RAIL COACH FACTORY, KAPURTHALA

CAI N O.: ED/CAI/028 Dated: 27.12.2023

COACH ALTERATION INSTRUCTION SHEET FOR MODIFICATIONS IN EXISTING LHB NON AC CHAIR CAR TYPE COACHES

This Coach Alteration Instruction Sheet has been issued for modification in existing **LHB Non AC Chair Car type coaches** wherein following steps are to be taken for modifications in the coach:

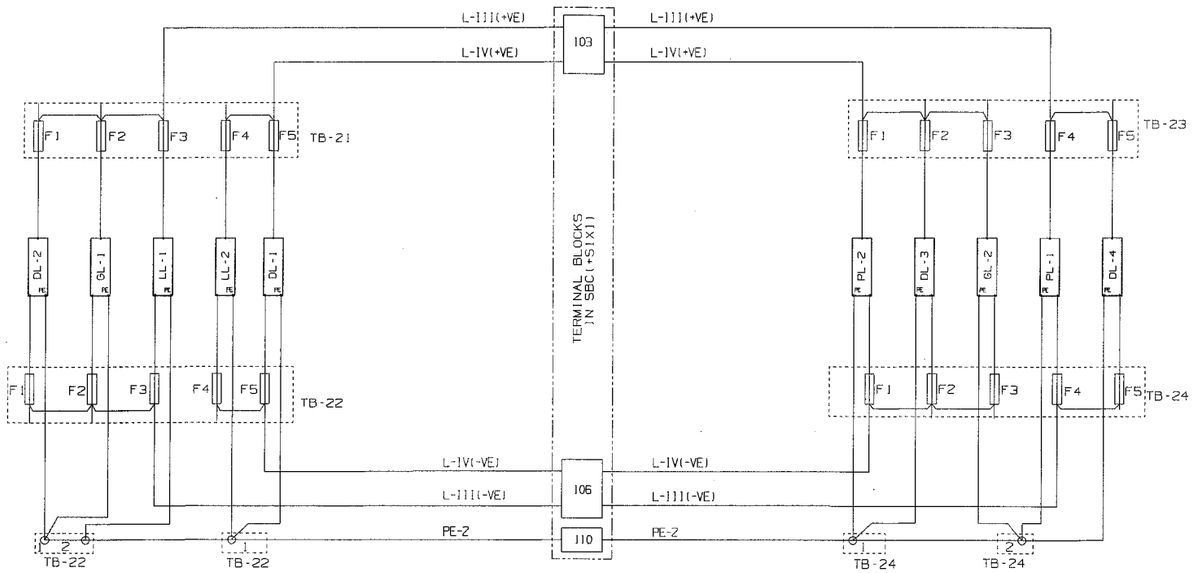
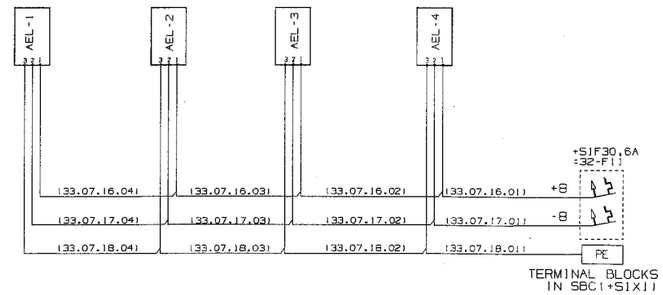
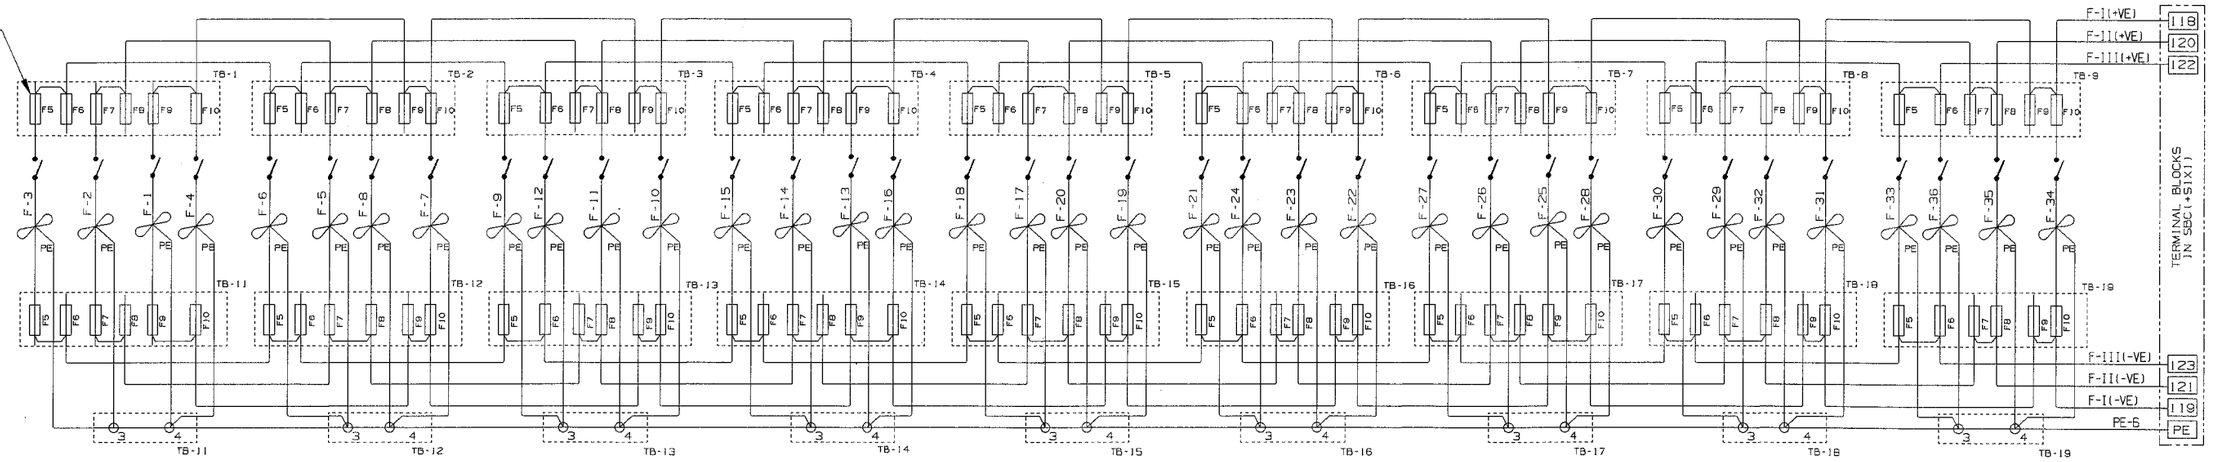
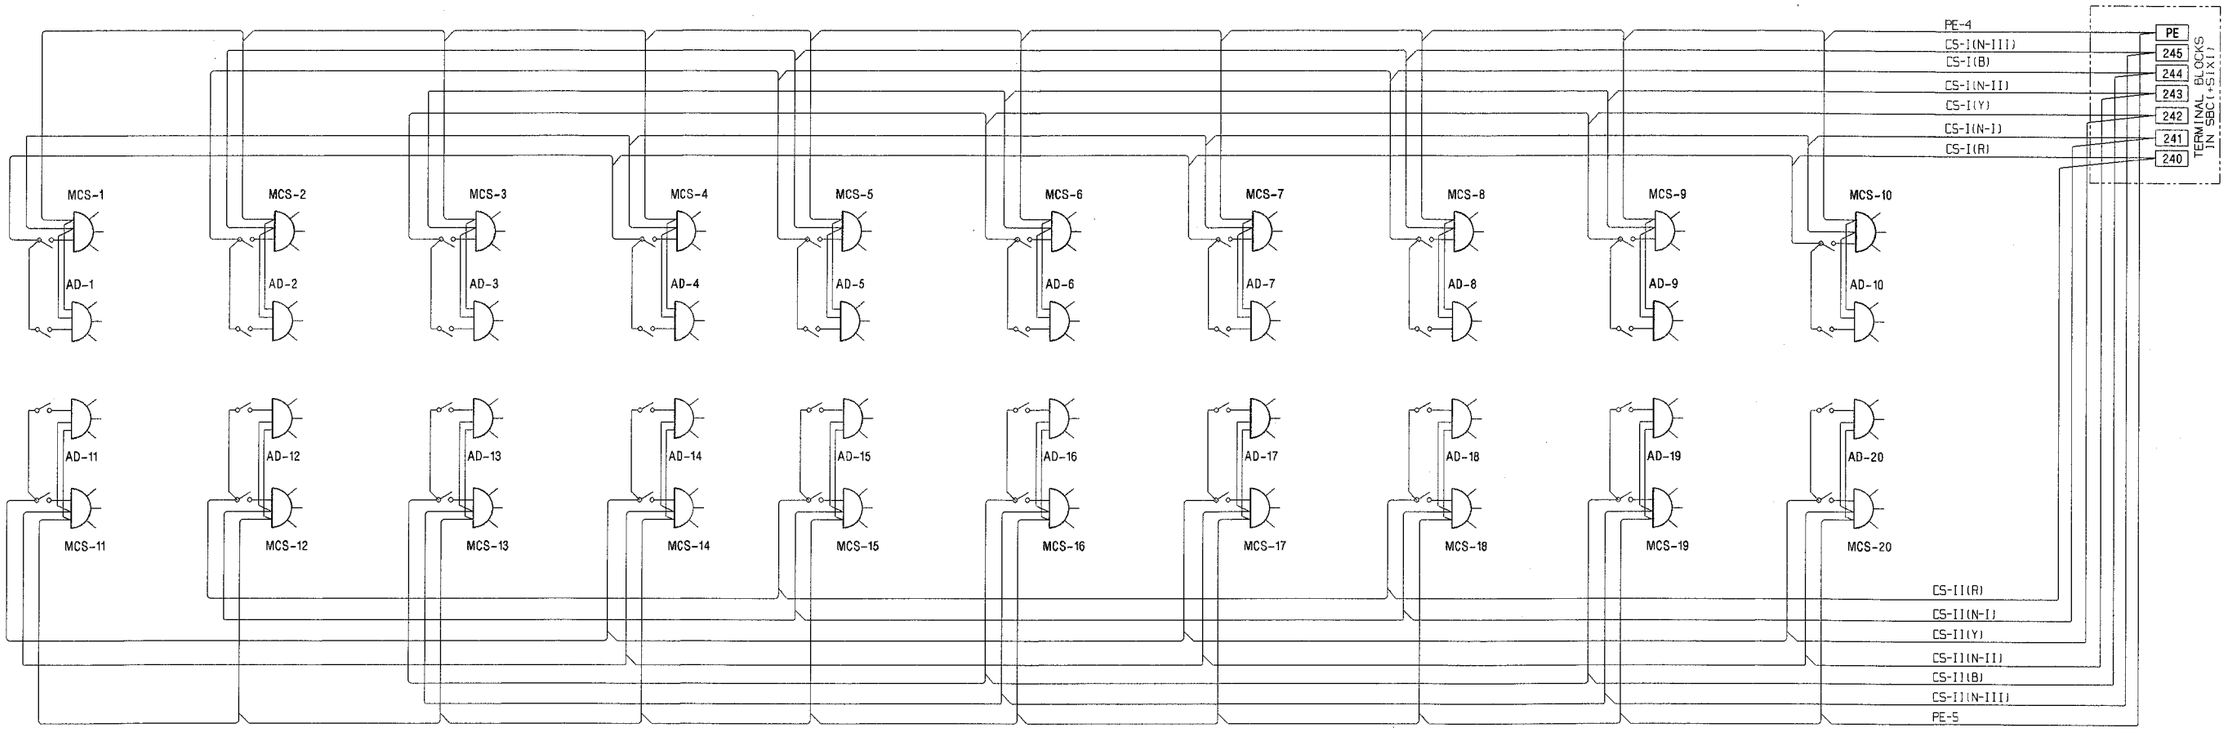
iii. Connect all the LIGHTS, FANS, NIGHT LIGHT circuits alongwith **Earthing** on the Cage clamp terminals with glass fuses in ref. to drawing no. **SKED 924** properly.

v. 110VDC Wiring of BLDC Fans and DC Lighting circuits shall be laid in Conduit-1 (Upper) already provided in Roof of coach and 110VAC wiring for mobile charging shall be laid in Conduit-2 (Lower) already provided in Roof as per undergiven details:

ii. However as per revised scheme to drawing SKED924, 06 nos./bay mobile charging sockets are to be provided in passenger area (i.e. 03 nos. on each side are to be provided in Passenger area on side wall)

iv. Mobile charging circuits shall be split up into three circuits inplace of existing two circuits. Additional wiring **(1x1.5sqmm (Blue)** for third circuit shall be laid in the existing conduit.

v. Connections of Mobile Charging sockets points in Switch Plate assemblies shall be made in ref. to drawing no. **SKED 924.**

ii. Connect the Male-Female WAGO type connectors supplied by the vendor alongwith fan supply. Connect the all the BLDC FAN circuits on the Cage clamp terminals with glass fuses in ref. to drawing no. **SKED 924** properly.

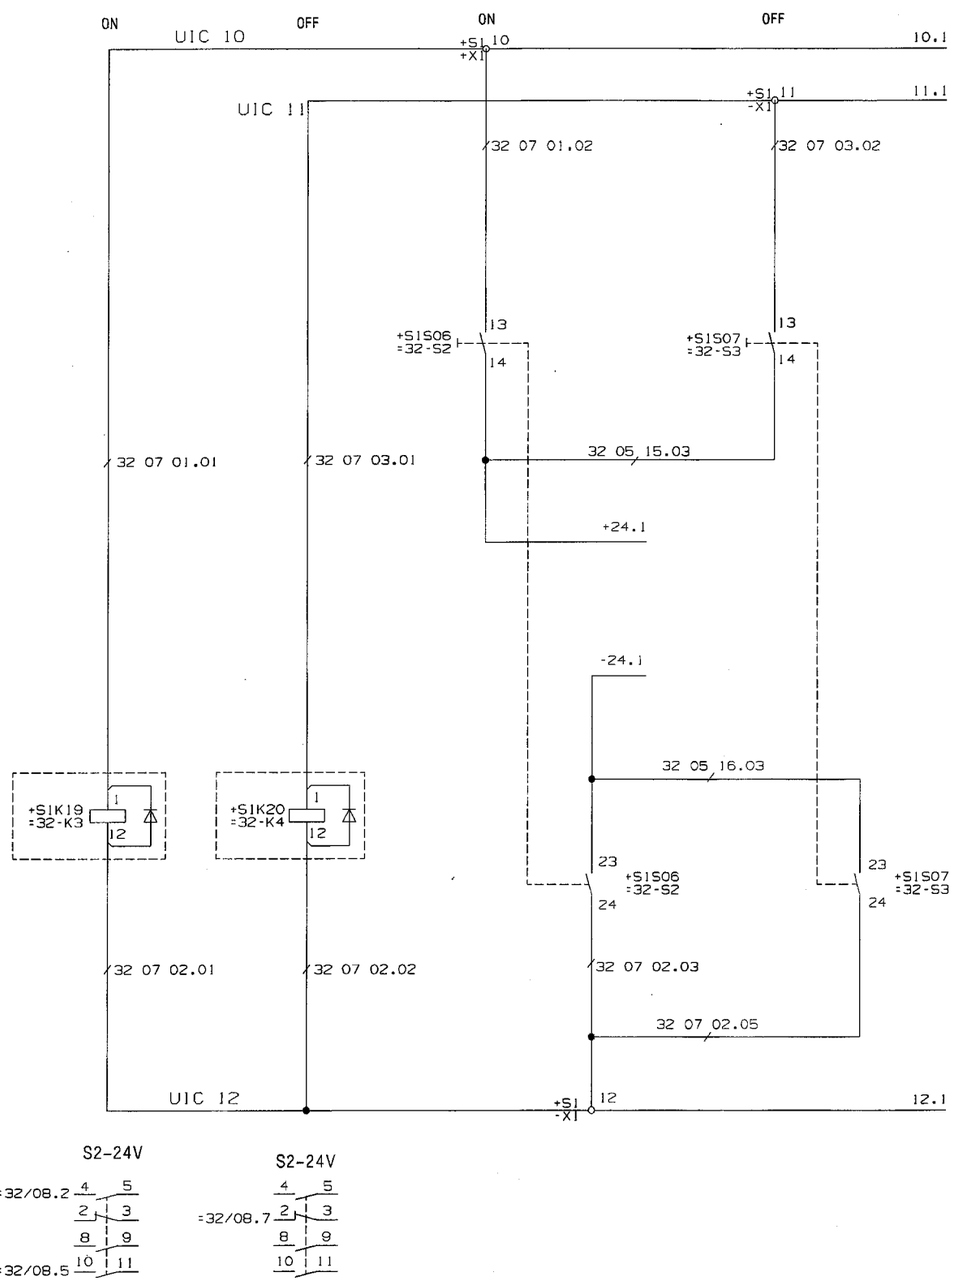
A.10	**Drawing no LS70202 sheet 10/13**	
	1	No change
A.12	**Drawing no LS70202 sheet 11/13 revised to drawing no SKED 931**	
	1	Minimal Voltage Relay MR9, 110 V 32U13/+S1K17 item 69 of the BOM deleted
A.13	**Drawing no LS70202 sheet 12/13**	
	1	No change
A.14	**Drawing no LS70202 sheet 13/13 revised to drawing no SKED 932**	
	1	MCB connected to DC in place of AC
	2	MCB 32F22/S1F38, 32F23/S1F39, 32F24/S1F40 Added of 6 Amps, 250 V DC
	3	MCB 32F25/S1F41, 32F26/S1F42 Added of 6 Amps, 250 V DC
	4	MCB 33F109/S1F109 Added of 6 Amps, 250 V AC
	5	RCBO 4-pole 16 amps, 30mA added for mobile charging circuit
	6	MCB +S1F30, 6AMP = 32-F11 to be used for connection of the AEL circuit
	7	MCB +S1F42, 6AMP = 32-F26 to be used for connection of the Reservation Chart Light
Note		
	1	**HOG modification as per RDSO Modification sheet no RDSO/PE/MS/AC/0051-2017 Rev-2, Amdt-1 (or Latest Edition) issued vide RDSO letter no EL/1.6.9.22 Dated 28/07/2014, 24/09/2015, 21/03/2017 may be incorporated (copy enclosed)**

CAGE CLAMP TERMINALS
WITH GLASS FUSES (CABIN/CORRIDOR SIDE)
FOR LHB EOG NON AC COACHES

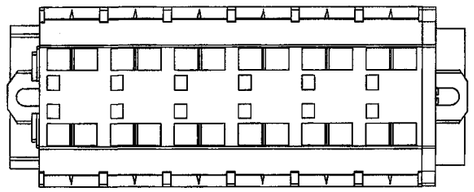
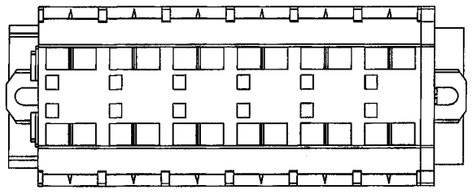
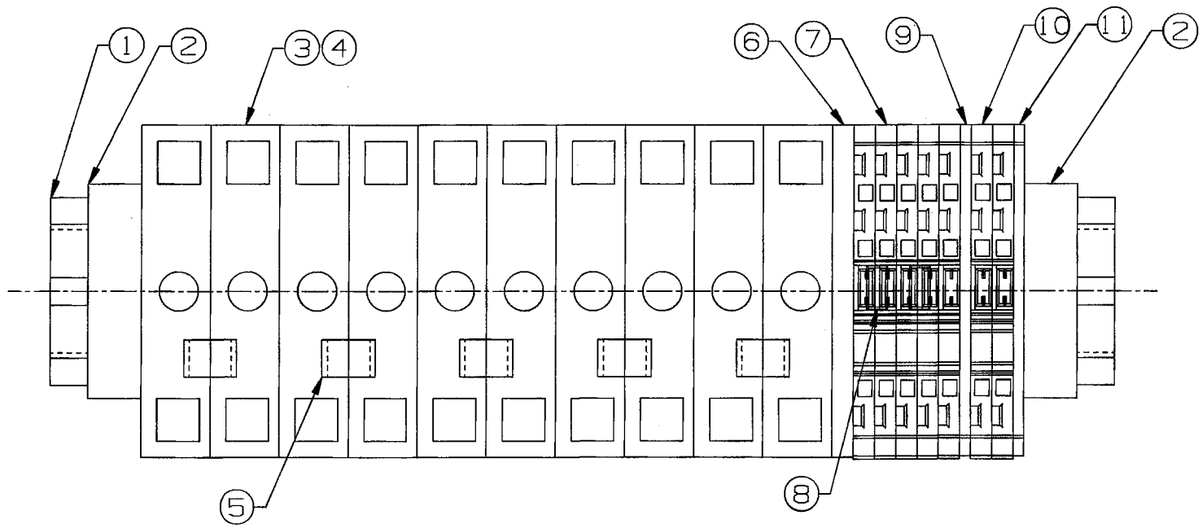
i. Cage clamp terminals with glass fuses as per drawing **SKED 933** shall be mounted on the existing bracket in each cabin on both side of the cabin area with the aid of suitable hardwares .

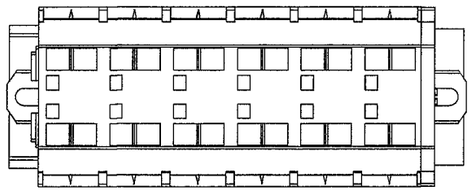
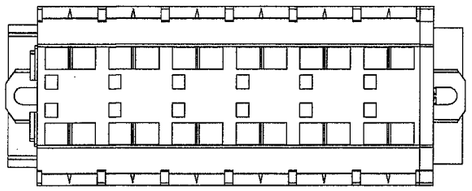
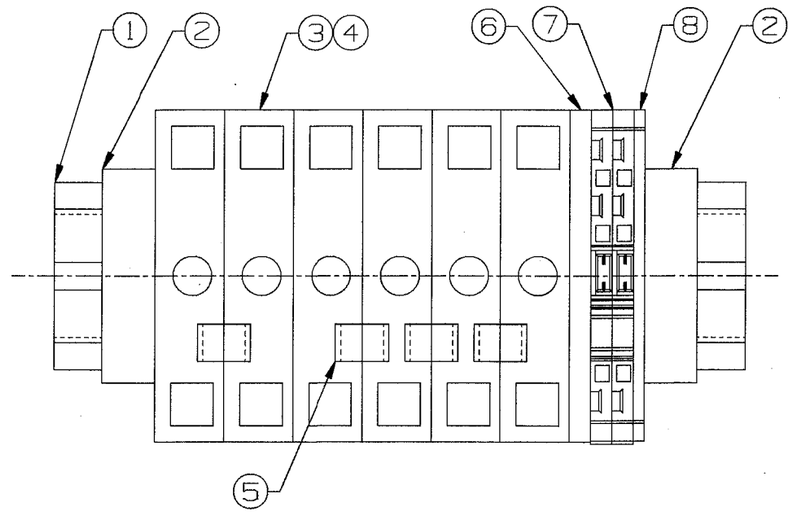
ii. Cage clamp terminals with glass fuses as per drawing **SKED 934** shall be mounted on the existing brackets in each doorway area on both side with the aid of suitable hardwares

MCB HOLDER
FOR SWITCH BOARD CABINET

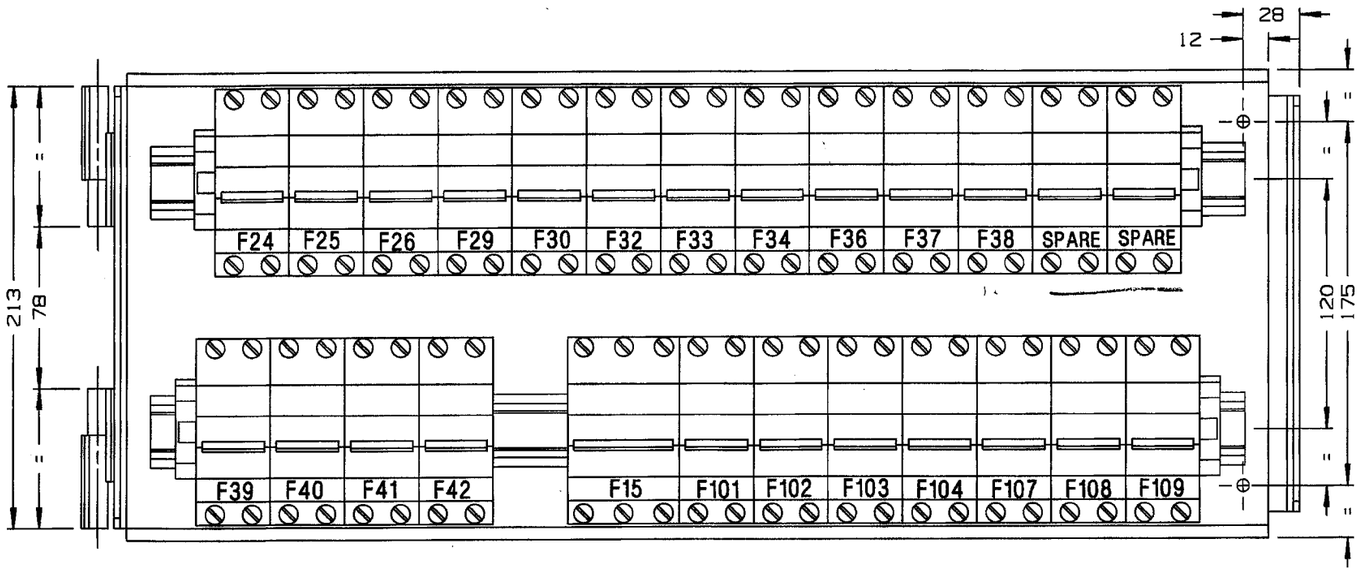
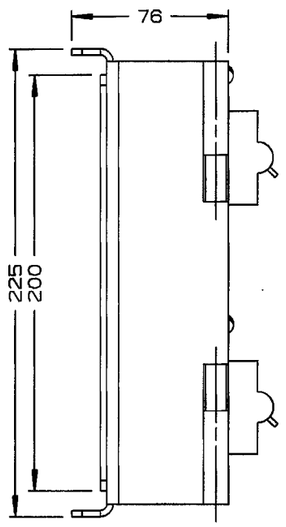
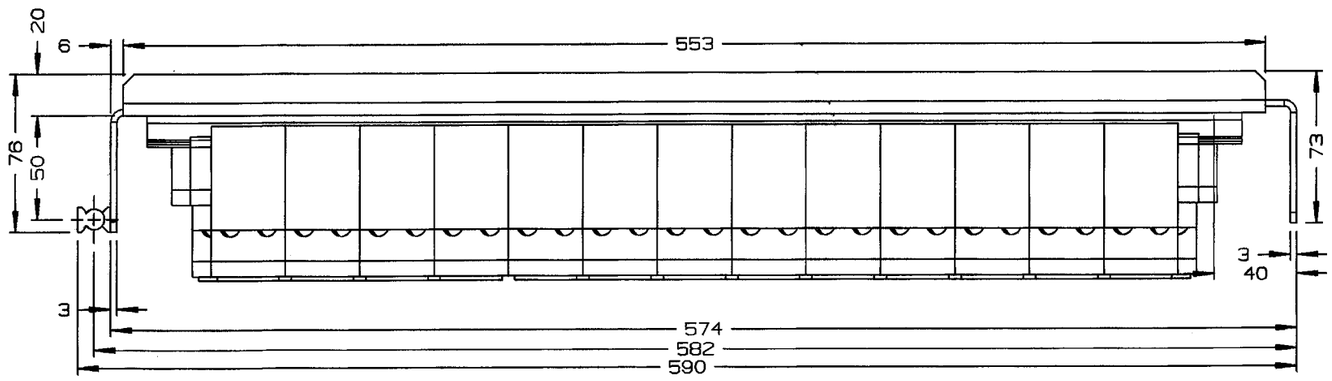
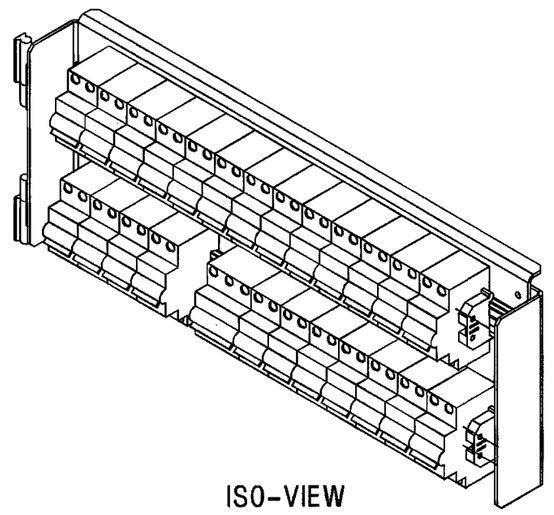
D	Modifications in the Structural drawing of the SBC :	
D.1	**Drawing no LS70201 sheet 3/14 Revised to drawing no SKED 935 sheet - 1**	
	1	Contactors 32K10/+S1K11, 32 K12/+S1K14, 32 K13/+S1K13, 32 K15/+S1K17, MR9, 110 V 32U3/+S1U2.3, 32K05/+S1K08 deleted, drawing revised
D.2	**Drawing no LS70201 sheet 6/14 revised to drawing no SKED 935 sheet - 2**	
	1	MCB re-arranged :as per reference-E
D.3	**Drawing no LS70201 sheet 1/14 revised terminal codifications chart.**	
	1	Terminal no. 83 to 86 changed to 280-837 of M/s WAGO in-place of 280-833 of M/s WAGO

EQUIP.BACK MOUNTING PLATE
FOR SWITCH BOARD CABINET
(IN REF. TO CAI. NO. ED/CAI/026, ED/CAI/027, ED/CAI/028)

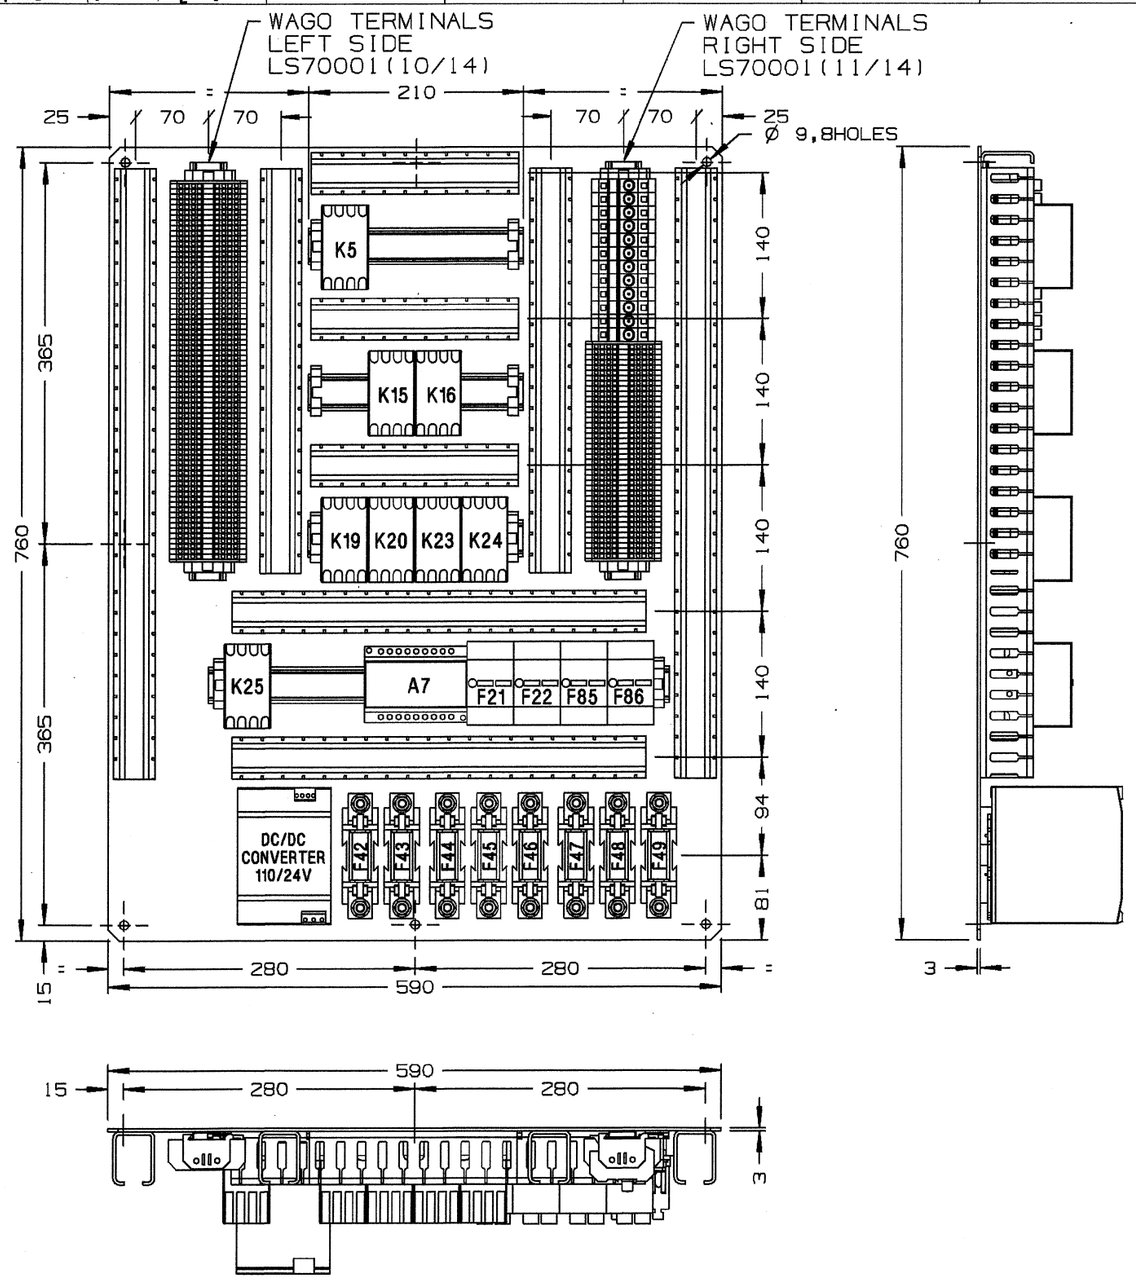
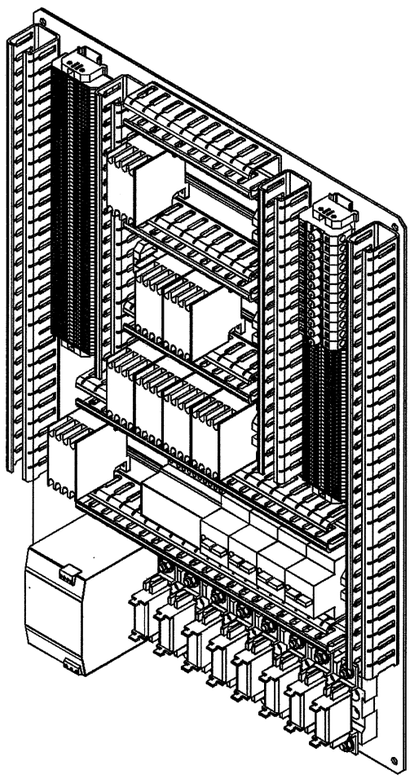
NOTE:- 1. ALL DIMENSIONS IN MM.
2. REF. DRG. NO.LS70201 (SHEET-3/14).
3. S1K11,S1K8,S1K13,S1K14,S1K17,S1K48 & S1A6 DELETED.
